Planning & Zoning Board

**MINUTES REGULAR MEETING
REYNOLDSBURG PLANNING & ZONING BOARD
April 16, 2026**

Summit Crossing – Major Site Plan, Preliminary Plat, Variance Requests

City Planning Staff Comments:

Upper Floor Assembly Plan

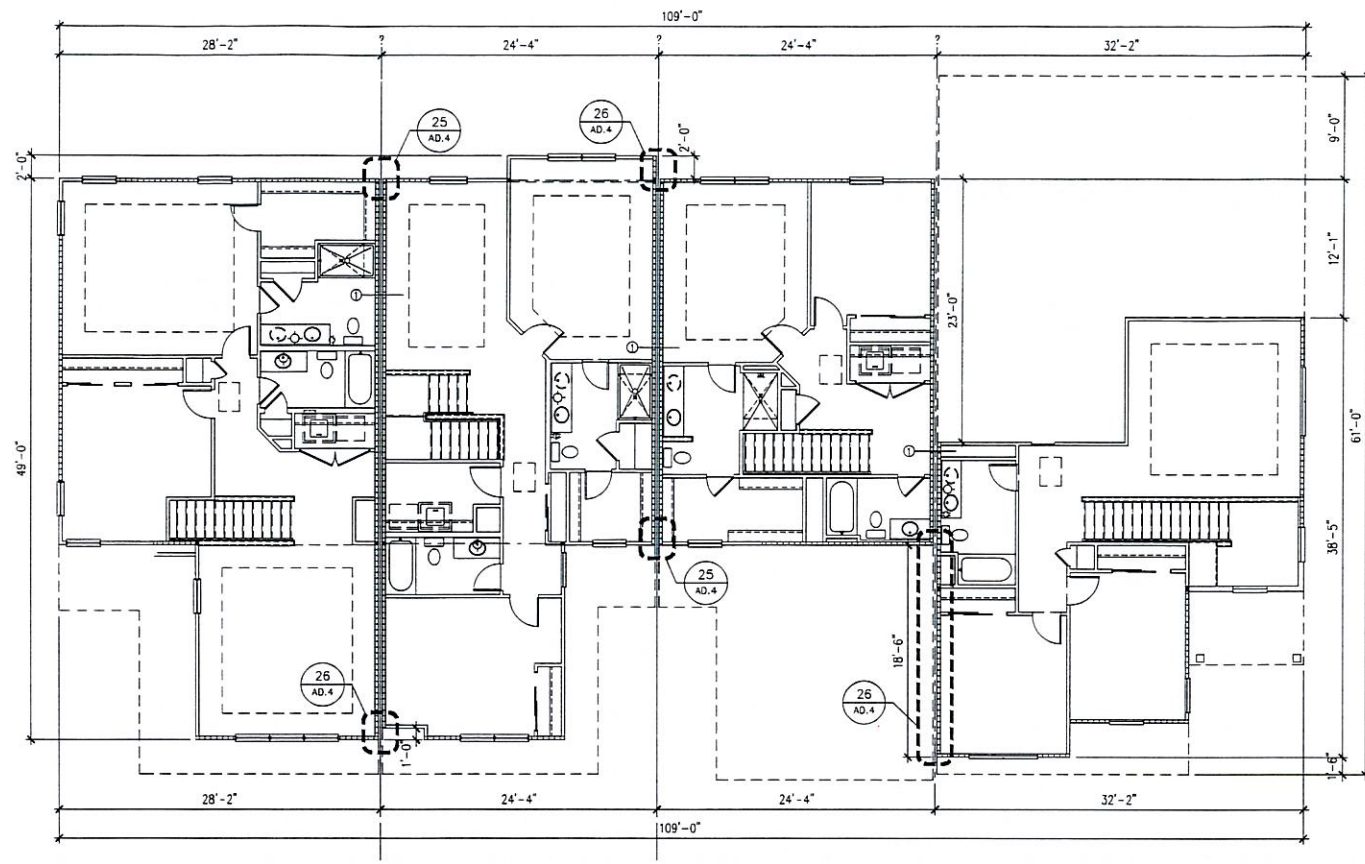
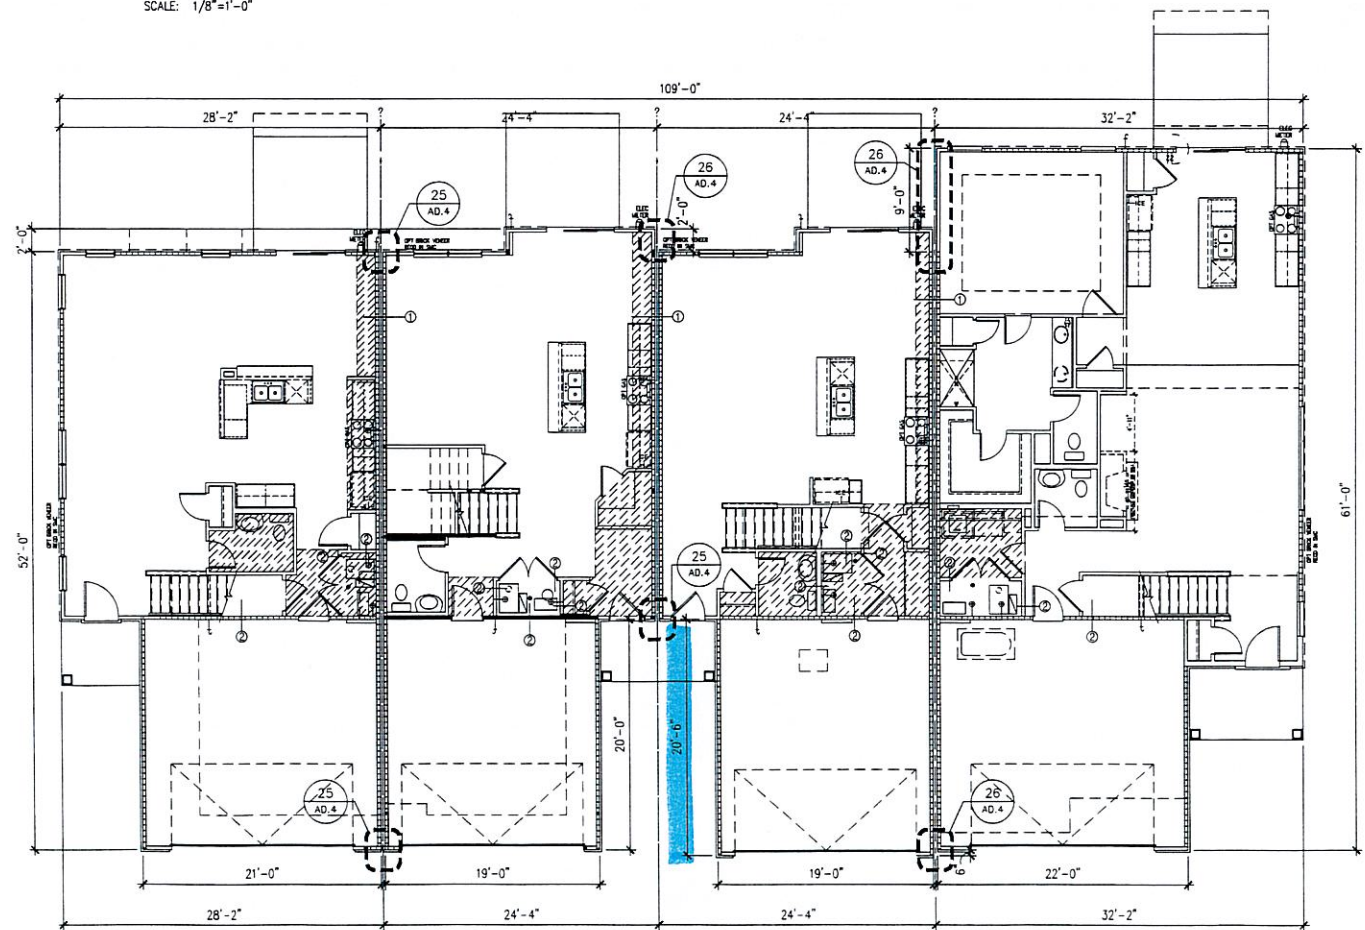
2. The applicant is requesting a variance to allow the garage to extend an additional 12 feet 6 inches more than the permitted 8 feet from the building's front façade. The applicant has provided in the packet, elevations/floor assembly plans providing three different units (not including the Ainslie unit) with six different options within those units that could meet the requirement, and not need a variance. The applicant has also submitted a four-unit design that has been approved by zoning that meets the requirement for which this variance has been submitted. The applicant has not stated how this particular unit has some type of special circumstance or condition that would deprive the property owner of the reasonable use of land, since they have other options and designs that meet this requirement.
